UNITED STATES PATENT AND TRADEMARK OFFICE

10/780,320

Office Action Summary	Application No.	Applicant(s)	
	10/780,320	CAVENEY ET AL.	
	Examiner	Art Unit	
	Philip Gabler	3637

DETAILED ACTION

Thiede et al. '498 Figures 2-4

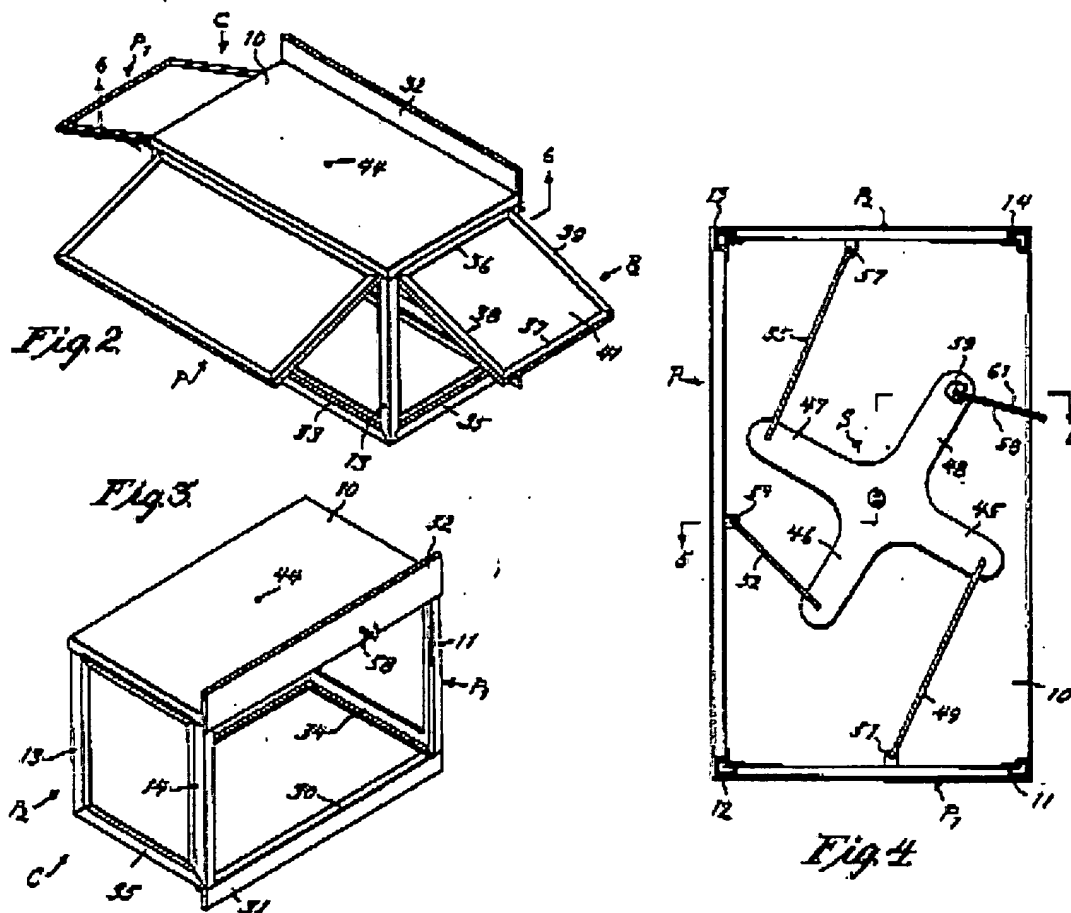
2. Claims 1 and 3 are rejected under 35 U.S.C. 102(b) as being anticipated by Thiede et al. (US Patent Number 3006498). Thiede (Figures 2-4) discloses a wall mountable cabinet comprising: a rear section (10-14, 31-35, etc.) having a top side (10) and a bottom side (members 30, 33, 34, etc.), the rear section including a cutout area (space defined by members 12, 13, 33, etc.) at one end (i.e. the front end) of the top side, wherein the cutout area is capable of allowing access for cables to enter the cabinet; and a front section (P) hingedly connected to the rear section at a pivot point (front edge of 10), wherein the cutout area is capable of allowing cables to rotate about the pivot point when the cabinet is moved from a closed position to an open position (the opening and closing of front section, P, for instance).

3. Regarding claim 3, Thiede further discloses two side access panels (P1 and P2) hingedly connected to the front section (through mechanism S and links 49, 52, and 55).

Exhibit 1: Hansson '362 Figures 1, 2, and 4

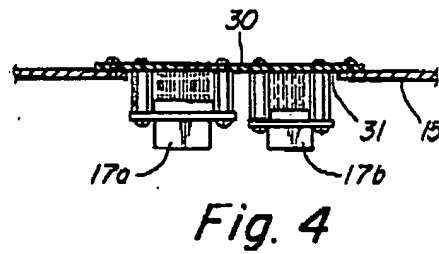
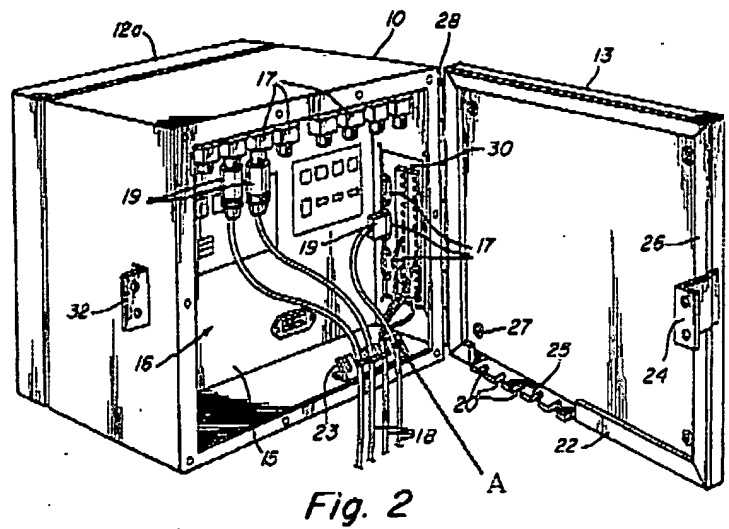
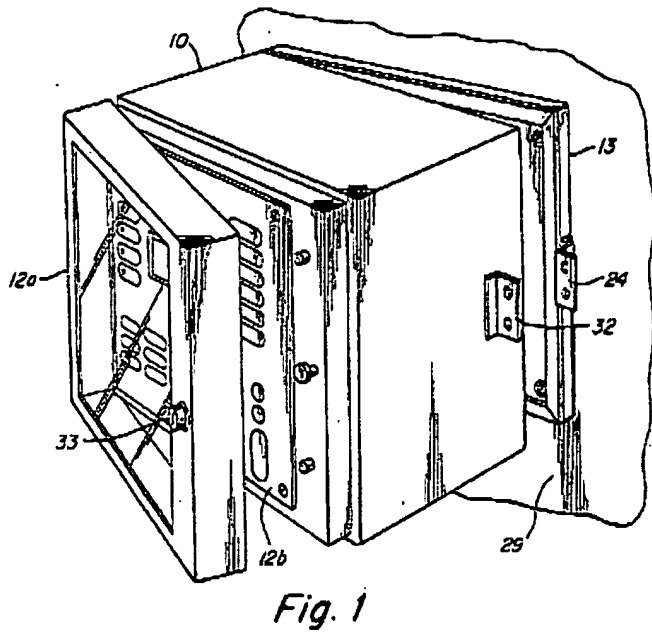
4. Claims 1, 4, 6, 7, 9, 11, 14, 17, 19, and 23 are rejected under 35 U.S.C. 102(b) as being anticipated by Hansson (US Patent Number 5568362). [Note that for the 35 USC 102(b) rejections in view of Hansson, Hansson's device is viewed in an inverted position as shown in Exhibit 2.] Hansson (Figures 1, 2, and 4) discloses a wall mountable cabinet comprising: a rear section (13) having a top side (at member 22) and a bottom side (opposite member 22), the rear section including a cutout area (20) at one end (the right end in Exhibit 2) of the top side, wherein the cutout area is capable of

6. Regarding claim 6, Hansson further discloses a slack cable manager (viewed as A in Exhibit 1) secured to a rail (23) mounted therein.

17. Regarding claim 6, Hansson further discloses a slack cable manager (viewed as A in Exhibit 1) secured to a rail (23) mounted therein.

Exhibit 2: Hansson '362 inverted Figures 1 and 2

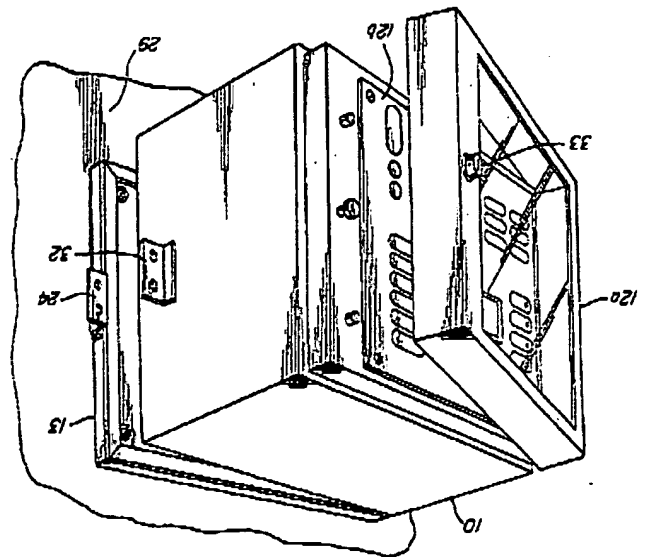
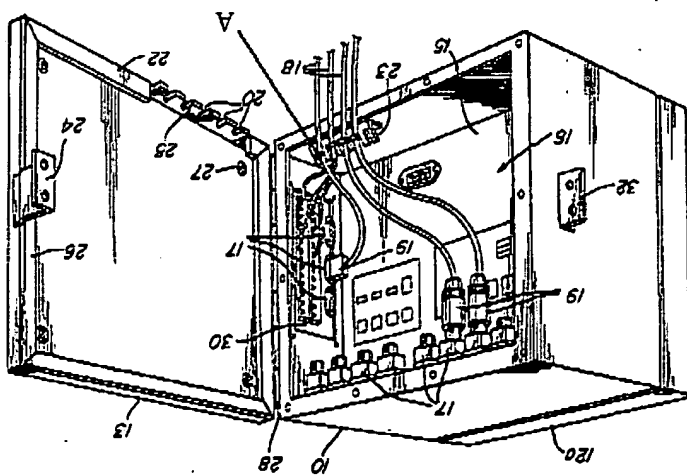
9. Regarding claim 11, Hansson discloses a wall mountable cabinet comprising: a rear section (13) having a top side (at member 22) and a bottom side (opposite member 22), the rear section including a cutout area (20) at one end (the right end in Exhibit 2) of the top side; and a front section (10) hingedly connected to the rear section (through hinge 28), the front section having a cable management ring (A, which points to a cable tie secured to tie bracket 23, the cable tie being viewed as a cable management ring) secured thereon, wherein when the cabinet is in a closed position, the cable management ring is vertically aligned with the cutout area (as is clear in Figure 2, where

Ehrenfels '129 Figures 1, 2, and 5

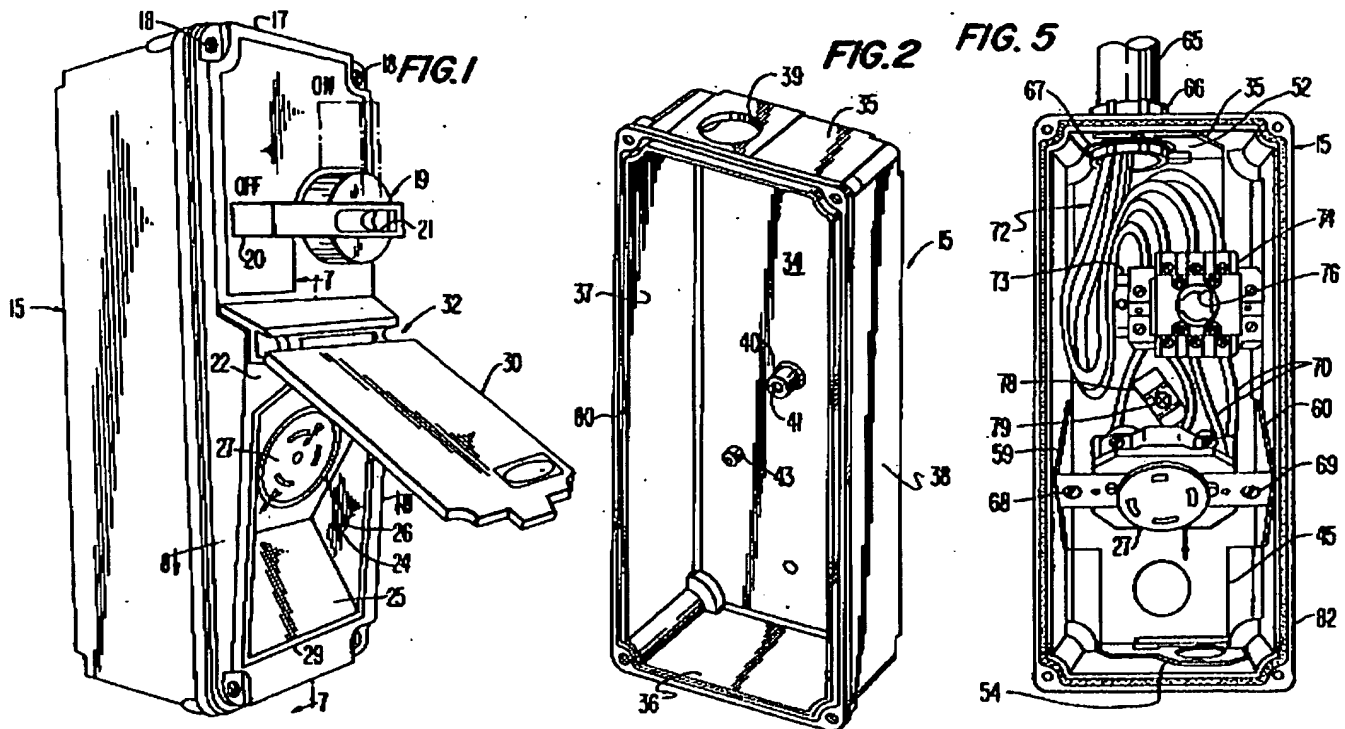
25. Claims 2 and 12 are rejected under 35 U.S.C. 103(a) as being unpatentable over Hansson in view of Ehrenfels (US Patent Number 5239129). Hansson discloses a wall mountable cabinet as recited in claims 1 and 11 as described above but does not disclose a duct positioned adjacent the cutout area. Ehrenfels discloses a wall mountable cabinet with a duct (65) adjacent to a cutout area (39). Accordingly, it would have been obvious to one of ordinary skill in the art at the time the invention was made to modify Hansson's cabinet to include a duct positioned adjacent to the cutout area as taught by Ehrenfels because this arrangement would protect cables routed through the cutout area.

Nelson et al. '966 Figure 17

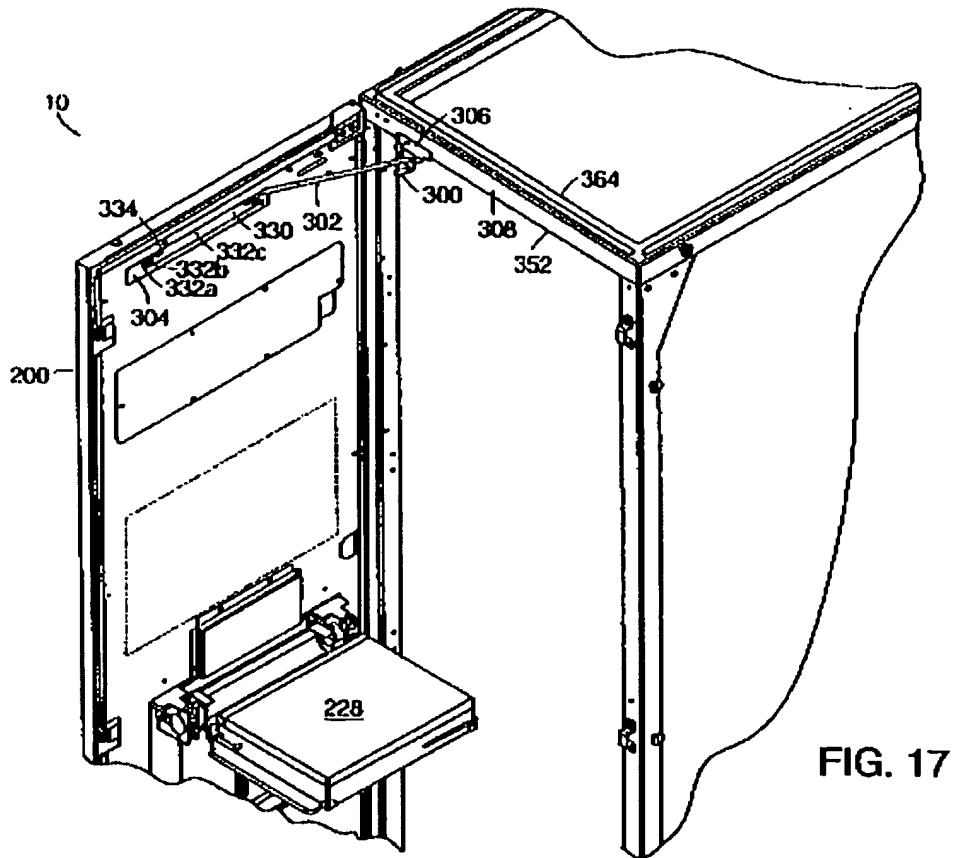
26. Claims 5 and 15 are rejected under 35 U.S.C. 103(a) as being unpatentable over Hansson in view of Nelson et al. (US Patent Number 6061966). Hansson discloses a wall mountable cabinet as recited in claims 1 and 11 as described above but does not disclose a rod which maintains the front section in an open position. Nelson (Figure 17) discloses a cabinet comprising a rod (302) which maintains the front section (200) in an open position about 90 degrees from the rear section (308). Accordingly, it would have been obvious to one of ordinary skill in the art at the time the invention was made to modify Hansson's cabinet to include a rod to maintain the front section in an open

position as taught by Nelson because this arrangement would facilitate access to Hansson's cabinet by providing a prop for the front section.
